UNITED STATES PATENT AND TRADEMARK OFFICE

APPLICATION NO.	FILING DATE	FIRST NAMED INVENTOR	ATTORNEY DOCKET NO.	CONFIRMATION NO.
10/646,643	08/22/2003	George William Dailey	2003P07970 US	9785

Office Action Summary	Application No.		Applicant(s)	
	10/646,643		DAILEY, GEORGE WILLIAM	
	Examiner		Art Unit	
	Timothy M. Ayres		3637

This is a final office action on the merits of application SN10/646,643.

King '090 Figure 1

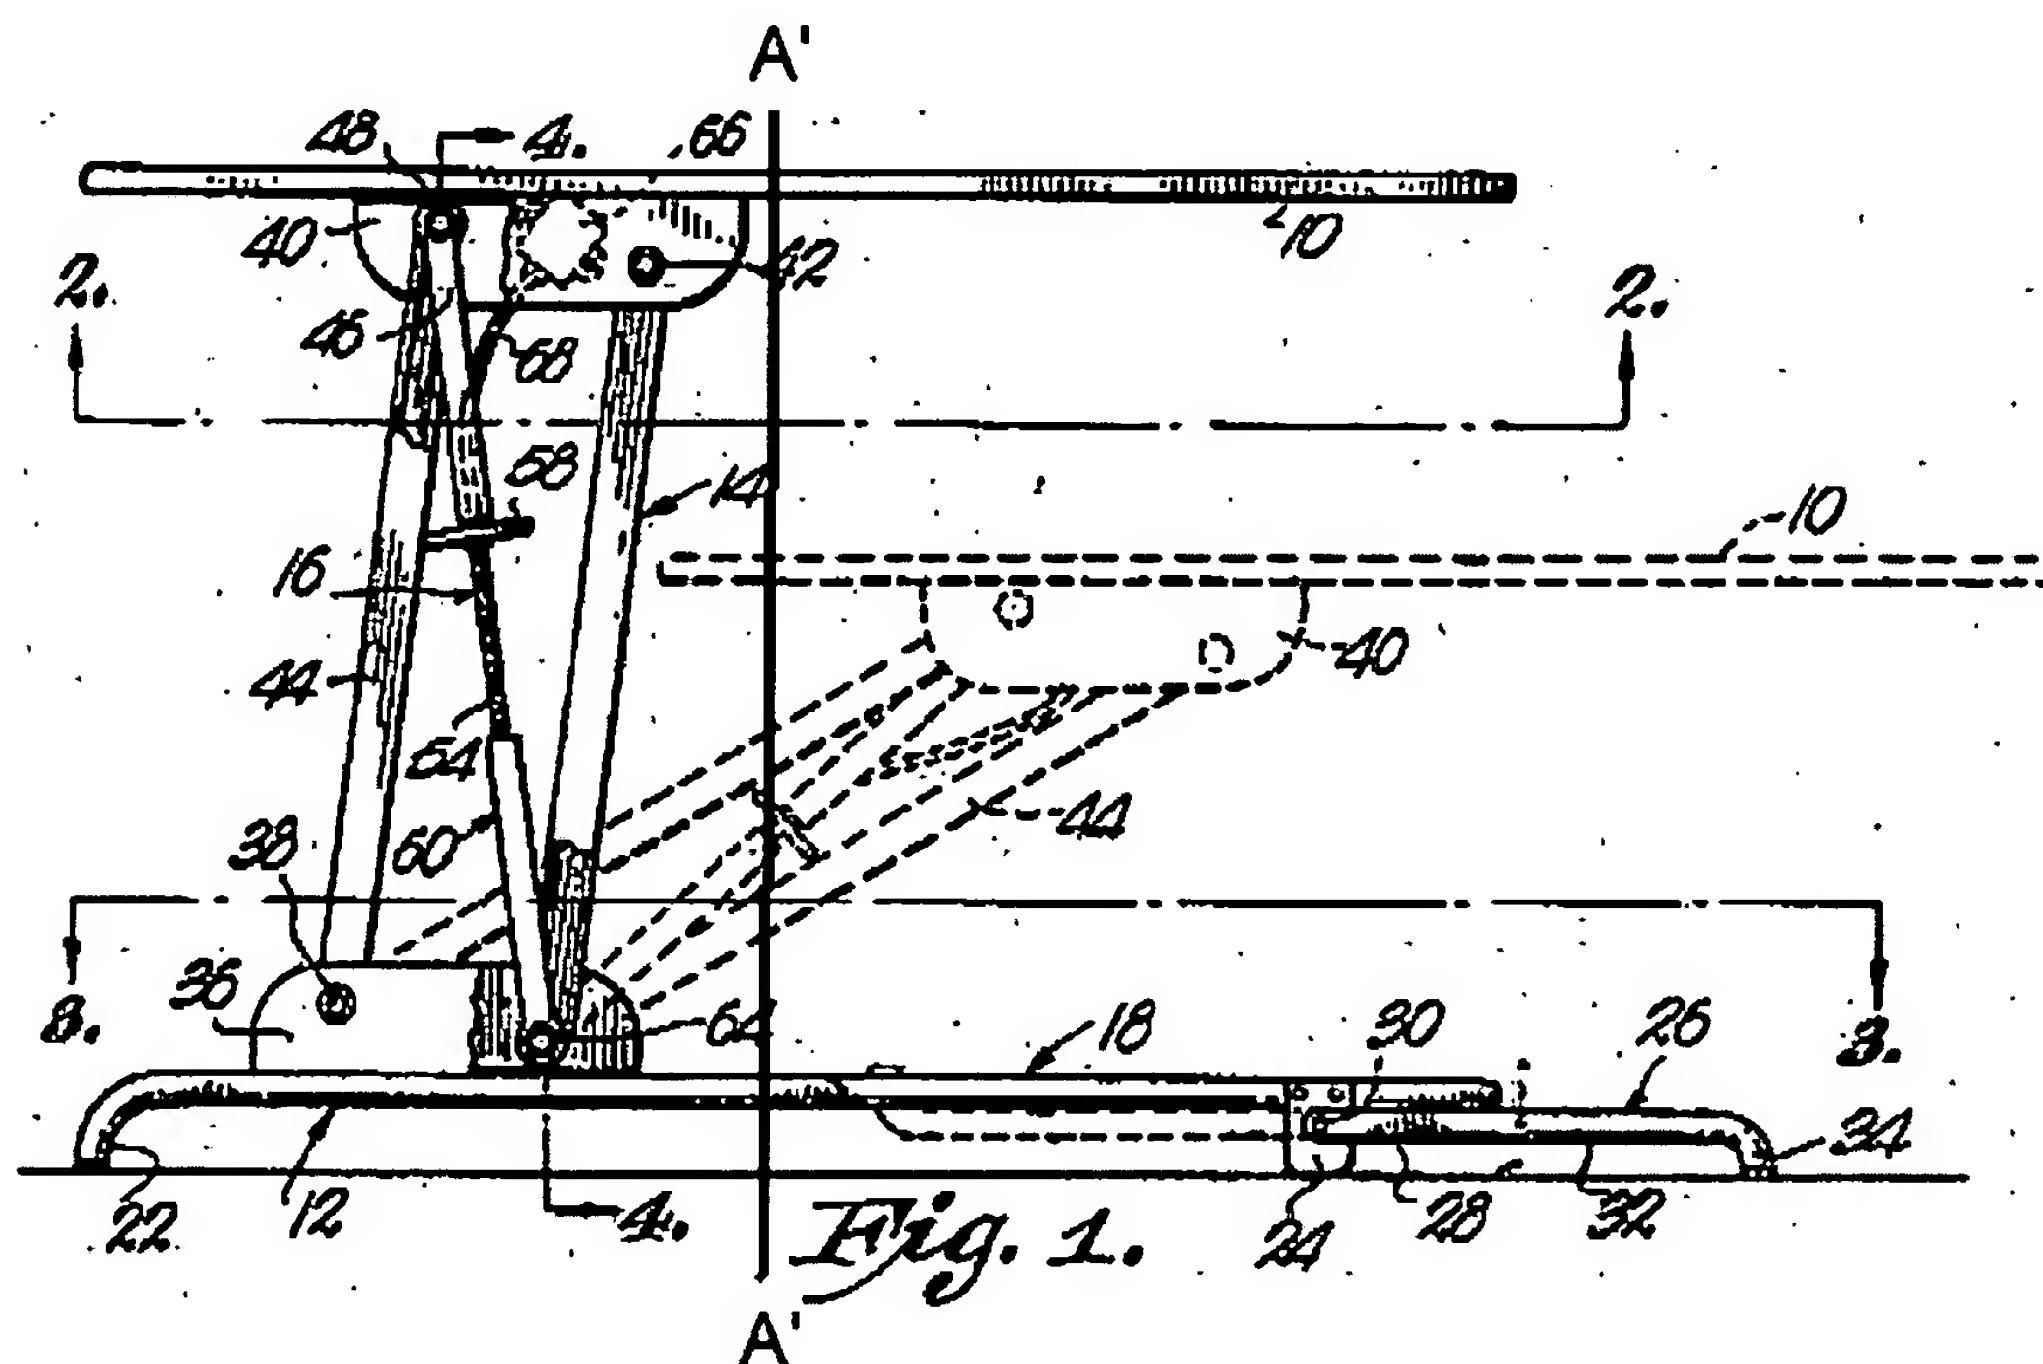
6. Claims 1-4 and 8 are rejected under 35 U.S.C. 102(b) as being clearly anticipated by U.S. Patent 3,288,090 to King. King '090 discloses an elongated planar member (10) that has a top and bottom side and inherently can support a patient. A support assembly (12) includes a base (18) that defines the base plane and a pedestal (36) disposed on the base (18). A plurality of elongated connecting arms (14), with a first end defined by pins (42) and a second end defined by pins (38). The first end of the elongated members (14) is pivotally attached through pins (42) to the bottom of the planar member (10) through flange (40). The second end of the elongated members (14) is pivotally attached through pins (38) to the base pedestal (36). The planar member (10) moves from a first position to a second position as shown in figure 1 with the elongated members (14) traveling through an axis that is orthogonal to the base.

7. The means for moving the planar member from the first position to the second position is a motor assembly (66, 68) with a screw member (54), which connects to the pins (38,42) and the connecting arms. The plane of the first position and the plane of the second position are parallel to each other and the base plane as shown in figure 1. The plurality of elongated members (14) is arranged in a four bar linkage.

19. Regarding the argument that the parallel linkage of King '090 does not travel through an axis that is orthogonal to the base. It is impossible for a connecting arm that has a solid pivot and some width to travel completely through any axis as implied by the applicant's interpretation of claim 1. It is interpreted by the examiner that each connecting arm just has to travel across one axis orthogonal to the base as shown in the marked up figure 1 below with axis A'-A' and not that an axis of the connecting arm has to be orthogonal at some point in the travel of the connecting arm or that the angle of attack has to be 90 degrees as used in the applicants argument on page 10 of the remarks filed received on 10/06/05 even though it does not appear in the claims.
